CITY OF ALBUQUERQUE

RE: **Lot 4 Block 5, Unit 5, S.A.D. 227**
Volcano Cliffs Subdivision
6512 Onyx Ct. NW
Grading and Drainage Plan
Engineers Stamp Date: 6/29/2020 (E10D071) Revised
Pad Certification Date: 1/14/20

6512 ONYX CT. NW, ALBUQUERQUE, NM 87120	CITY OF ALBUQUERQUE, BERNALILLO COUNTY	NEW MEXICO
LOT 4, BLOCK 5 UNSER CLIFFS SUBDIVISION		
MARTINEZ — LOT 4 GRADING & DRAINAGE PLAN		
McDowell Engineering, Inc.		
7820 BEVERLY HILLS AVE. NE ALBUQUERQUE, NM 87122		
TELE: 505-828-2430 FAX: 505-821-4857		
Designed JSM	Drawn STAFF	Checked JSM
File QUA0119L	Date NOVEMBER, 2019	Sheet 1 of 1

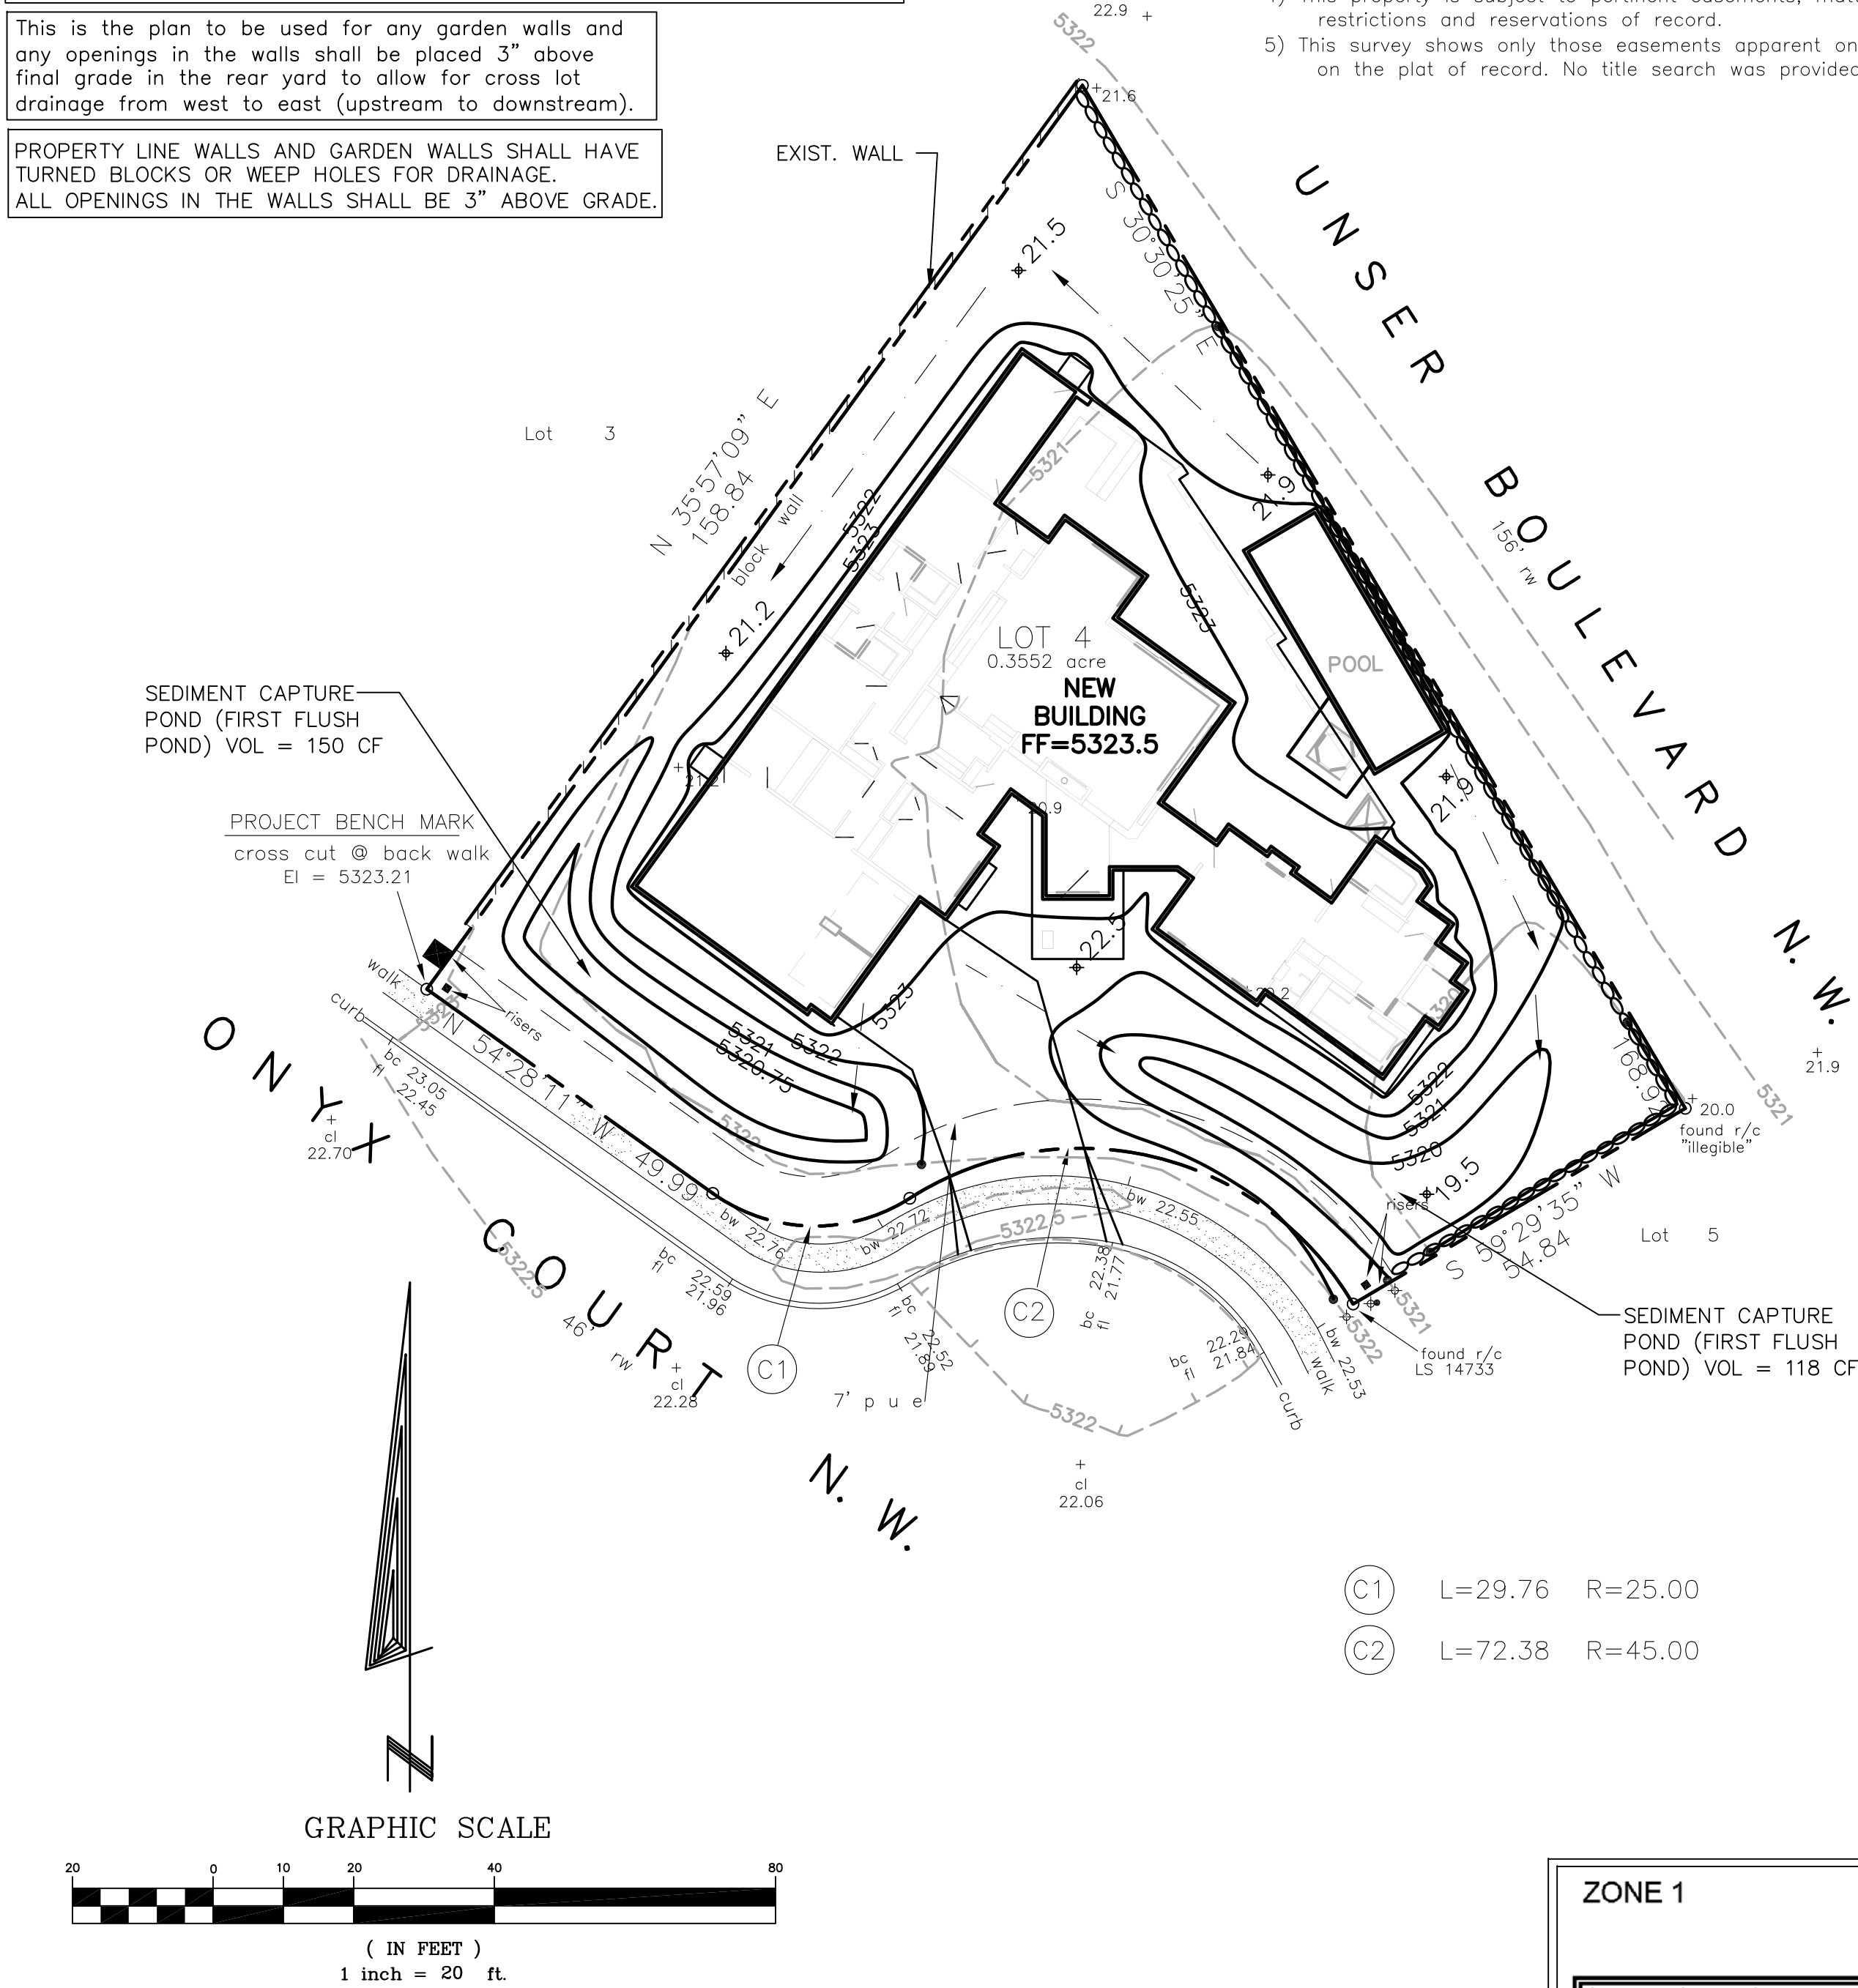
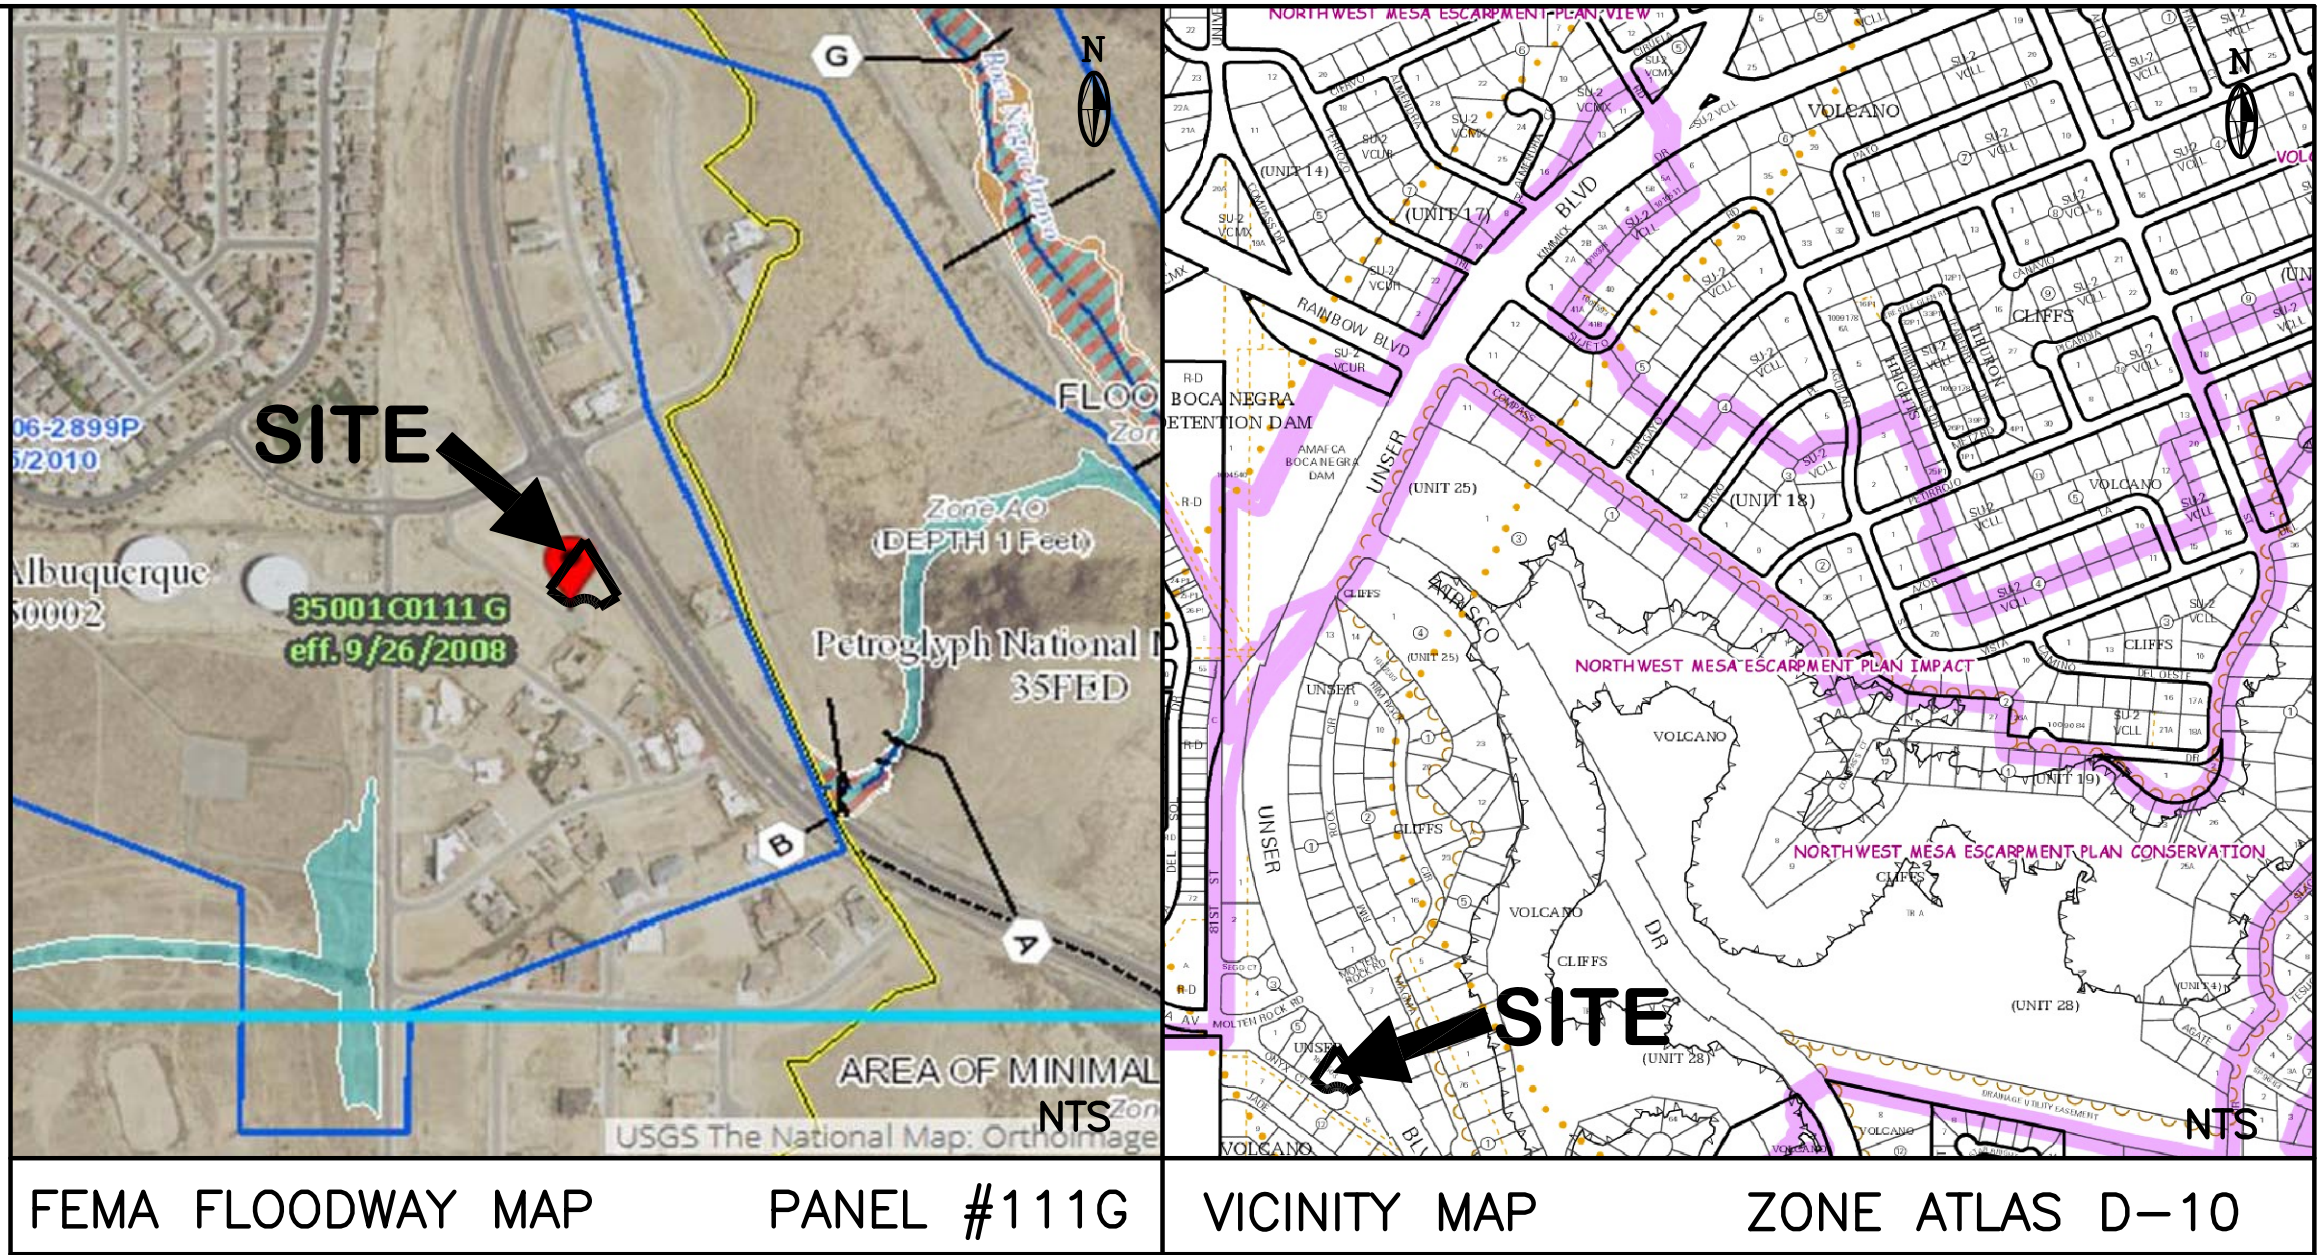
Based upon the information provided in your submittal received 4/1/2020, this plan is approved for Building Permit.

Reiterate to the Owner/Contractor that a separate permit for any garden/retaining wall must be obtained, with the approved G&D plan dated 12/4/18.

Prior to Certificate of Occupancy release, Engineer Certification per the DPM checklist of this plan will be required. A fee of \$75.00 will be charged for this certification. If an additional resubmittal is required a \$75.00 fee for each resubmittal will be charged.
